# Pre-Paint (Plaster & Waterproofing ) Report

Inspection Date: 9 Jul 2021

Property Address: North Melbourne area

Nº 2  
OUT VERTICALLY  
BY 12 mm  
TV AREA

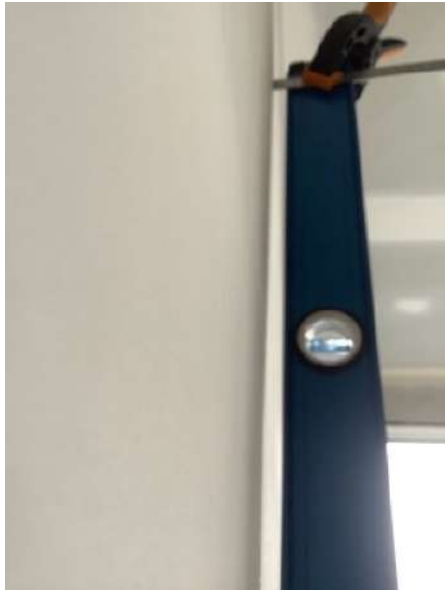
TV area, out by 12 mm over 1.8 m, vertically

A registered builder should be appointed to assess the defect and perform rectification works as necessary.

Nº 3  
UPSTAIRS HALL WAY  
OUT VERTICALLY  
BY 10 mm

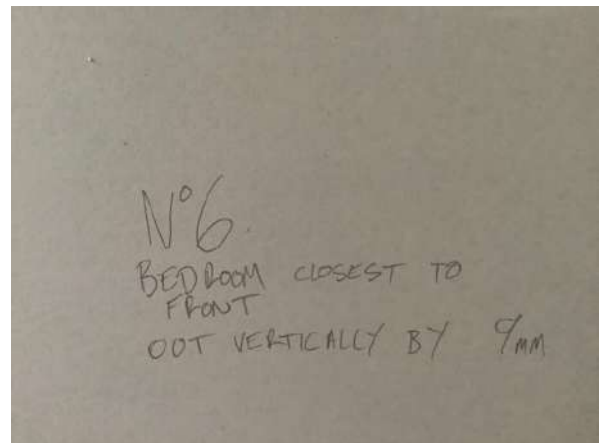
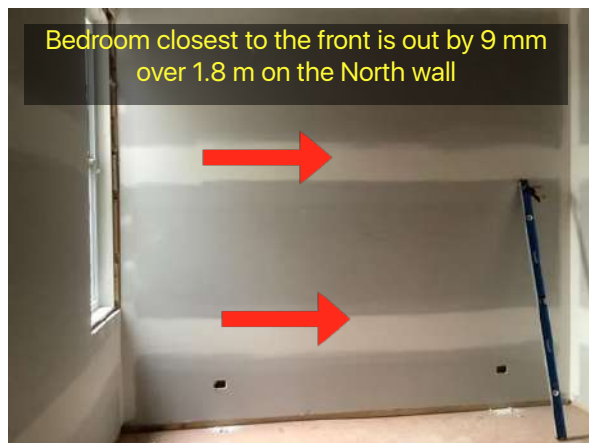
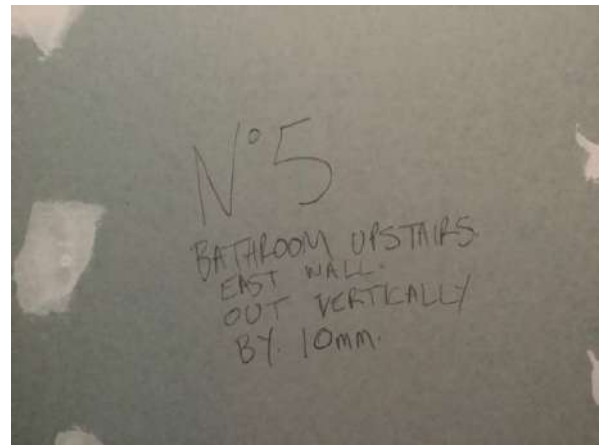
Upstairs hallway, out vertically by 10 mm over 1.8 m

N<sup>o</sup> 4  
OUT VERTICALLY  
BY 12mm  
UPSTAIRS MIDDLE S/ROOM  
EAST WALL

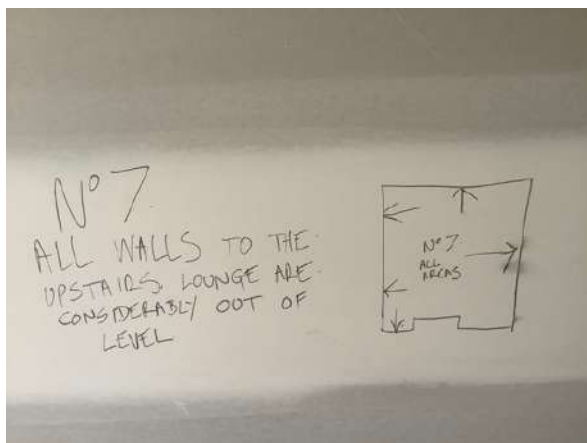
Upstairs middle bedroom on the east wall. The wall is out 12 mm over 1.8 m

Finding: Water Proofing - Inadequate / Defective - Non Compliant

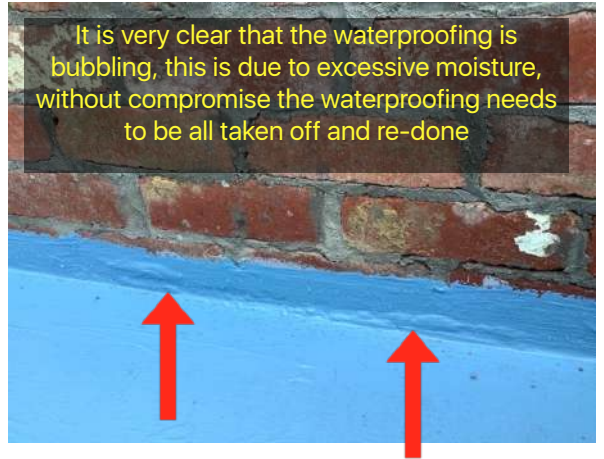
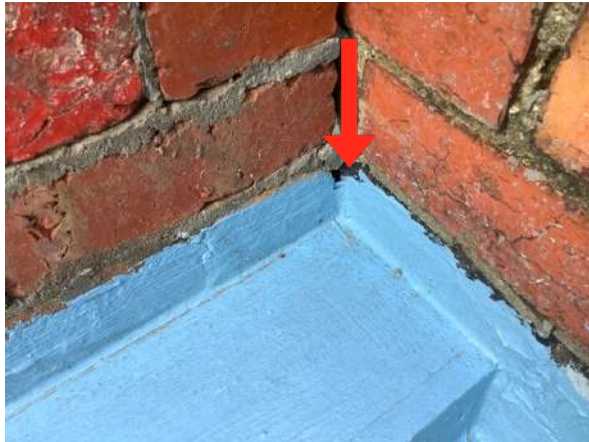
The photos are examples of the non-compliant and defective works. It is very difficult to inspect some areas of the waterproofing due to the lack of care to the waterproofing.

It appears that water proofing to the wet area/s has non-compliant areas and does not comply with Australian Standards and that the incorrect application of water proofing techniques has occurred in areas.

It is highly advised that adequate waterproofing materials be installed to all wet areas to comply with Australian Standards and protect all areas against water damage.

All repairs must be completed prior to the installation of the tiling and/or any other products used .

Finding: Wet Areas - Flashing At Floor Level Required.

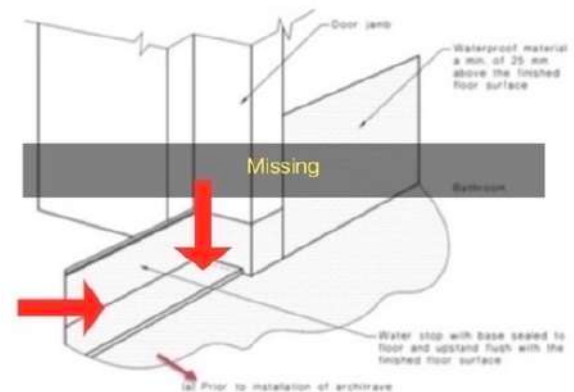
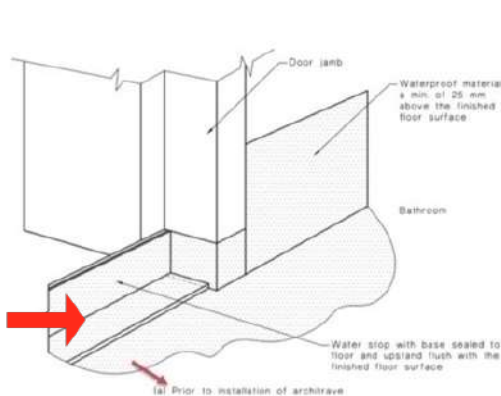
Diagrams attached as per AS 3.9.1.2 Perimeter Flashing At Floor Level Openings.

Waterproofed areas must be sealed to all perimeters.

The end of the tiles does not have the water stop at the end of the where the tiles will finish.

The builder must install this item and complete the waterproofing, before the tiles are installed.

Finding: Balcony drainage – water pooling

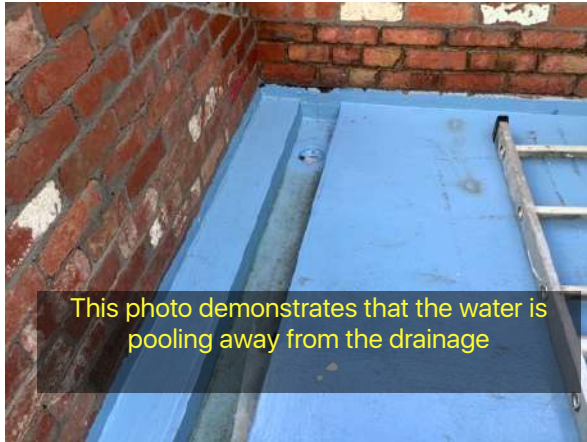
The balcony drainage system is holding water, this is called water pooling and is classed as defective workmanship.

I do not see how this can be repaired other than to rework the drainage system and redo the waterproofing.

Finding: Water Proofing - Covered With Builders Debris

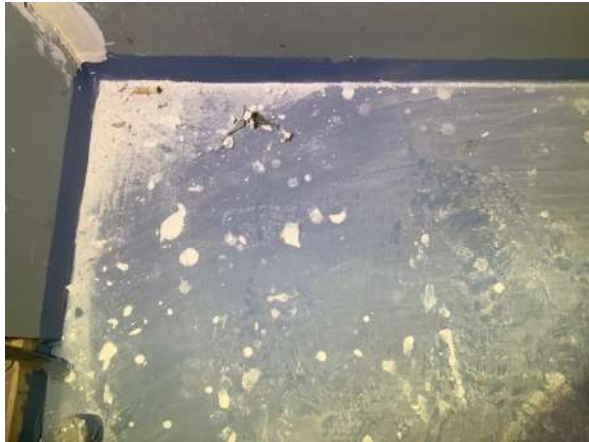
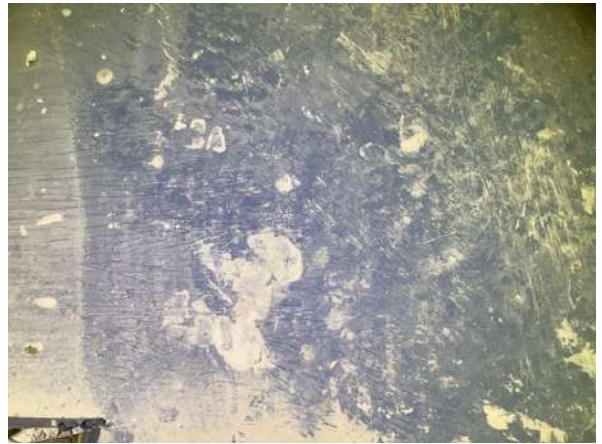
At the time of the inspection the waterproofing was not covered and protected. This has created excessive builders debris such as plaster, dust, etc onto the waterproofing. It is impossible to perform an inspection with the lack of respect to the waterproofing.

I highly recommend the builder provide to the client clean waterproofing services in order for us to perform an accurate inspection.
